Docket No. 50-266

Technical Specification Change No. 4
License No. DPR-24

CHANGE NO. 4 TO
TECHNICAL SPECIFICATIONS FOR
FACILITY OPERATING LICENSE NO. DPR-24
FOR POINT BEACH NUCLEAR PLANT UNIT 1
WISCONSIN ELECTRIC POWER CO.
WISCONSIN MICHIGAN POWER CO.
DOCKET NO. 50-266

FIGURE 15.2.1-1
CORE DNB SAFETY LIMITS
POINT BEACH 1 - CYCLE 2

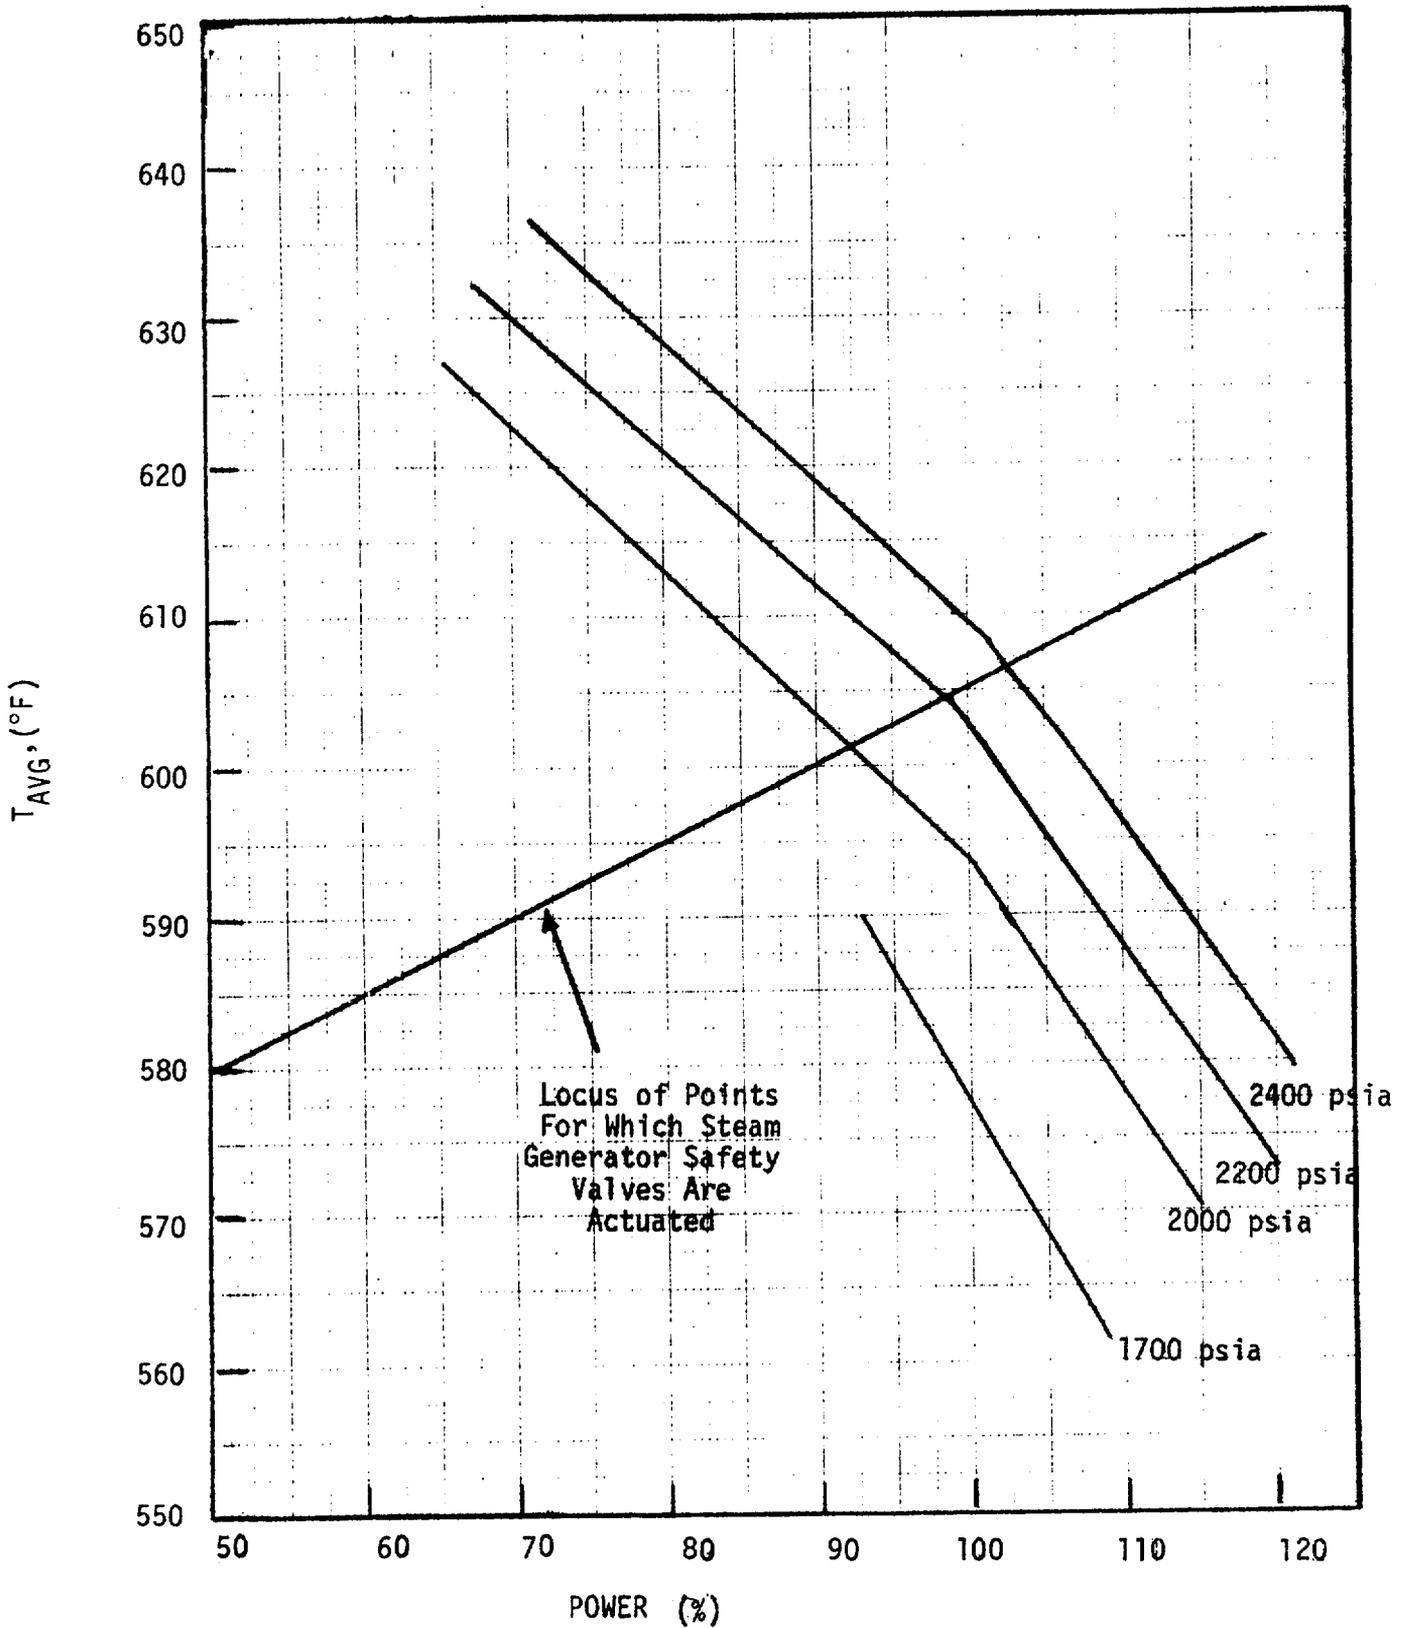
The curves of Figure 15.2.1-1 represent the loci of points of thermal power, coolant system pressure and average temperature for which the DNB ratio is no less than 1.30. The area of safe operation is below these lines. The safety limits curves have been revised to allow for heat flux peaking effects due to fuel densification and flattened fuel cladding sections.

Additional peaking factors to account for local peaking due to fuel rod axial gaps and reduction in fuel pellet stack length as well as a penalty to account for rod bowing, have been included in the calculation of the curves shown in Figure 15.2.

These curves are based on an $F_{\Delta H}^N$ of 1.58, a 1.55 cosine axial flux shape, and a DNB analysis as described in Section 4.3 of WCAP-8050 "Fuel Denficiency, Point Beach Nuclear Plant Unit 1 Cycle 2," (including the effects of fuel densification and flattened cladding).

Figure 15.2.1-1 also includes an allowance for an increase in the enthalpy rise hot channel factor at reduced power based on the expression:

Changes to the Technical Specifications have been made in Section 2.1 to limit fuel residence time to 8000 EFPH; to Section 2.3 to reduce the high flux set point to 108% of rated power and to revise the overtemperature constants; to Section 3.1-D to limit primary to secondary steam generator leakage so that in the event of an overpower transient and failure of all flattened fuel rods the radiation exposure at the site boundary will not exceed the limits of 10 CFR 20; and to Section 3.10 to incorporate revised full length and part length control rod insertion limits, power distribution limits, and additional power distribution surveillance requirements.

FIGURE 15.3.1-1

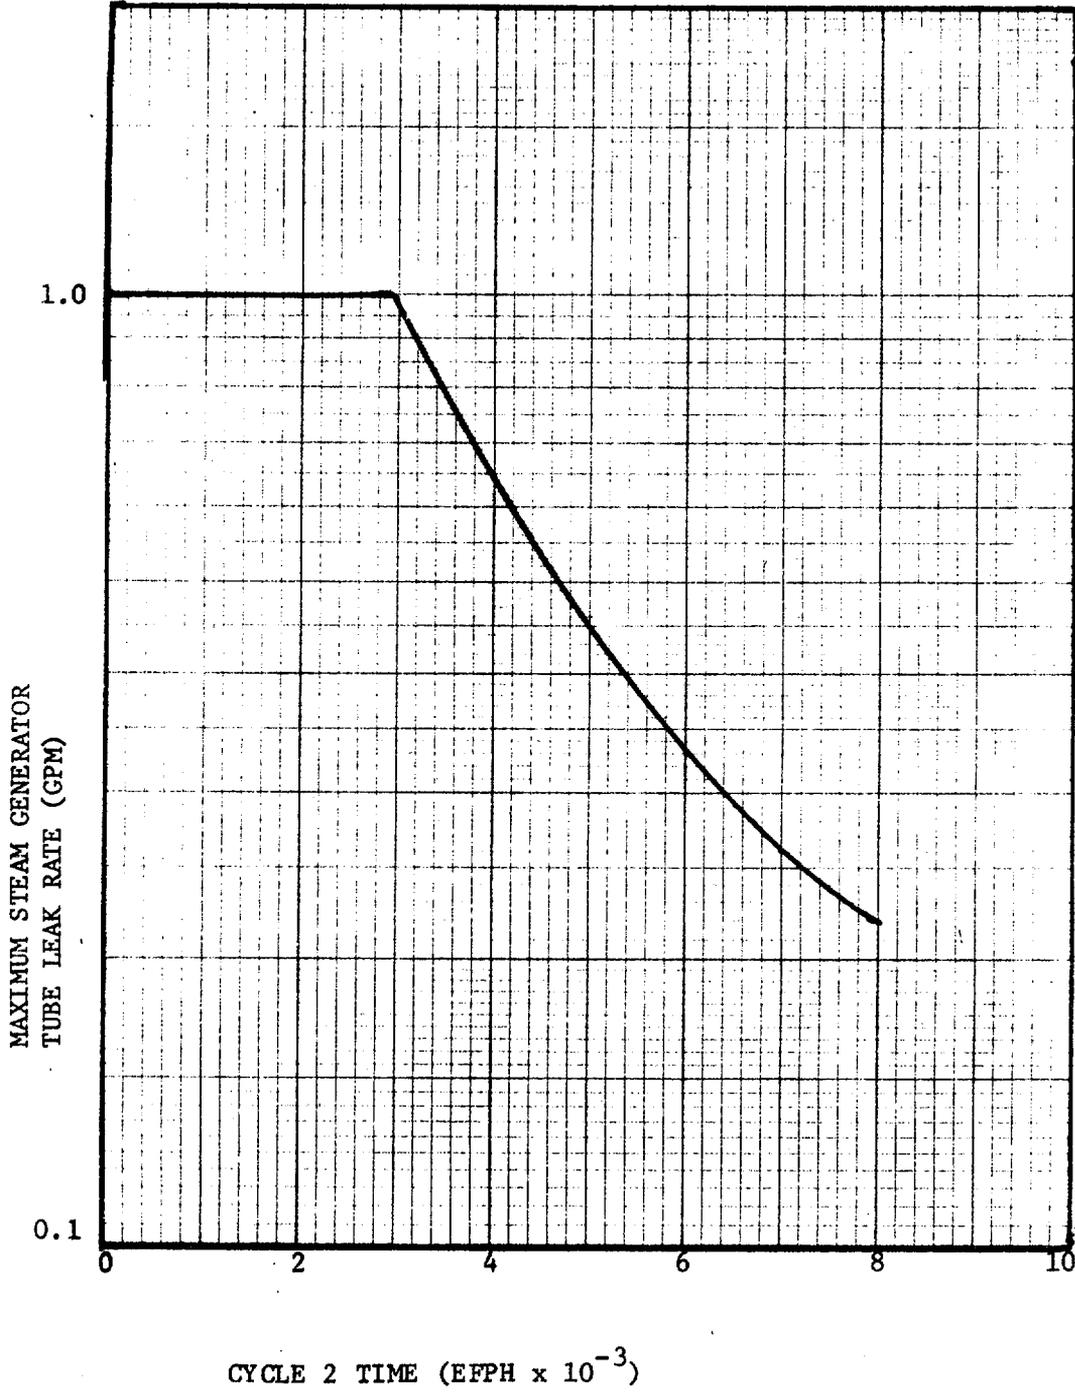
Steam generator tube leakage limits are based upon offsite dose considerations as limited by 10 CFR 20 in the event of an overpower transient with the presence of collapsed rods and 10 CFR 100 limits in the event of a steam line break or rod ejection accident.

Based on overpower transient 10 CFR 20 dose limits of 1.5 Rem thyroid
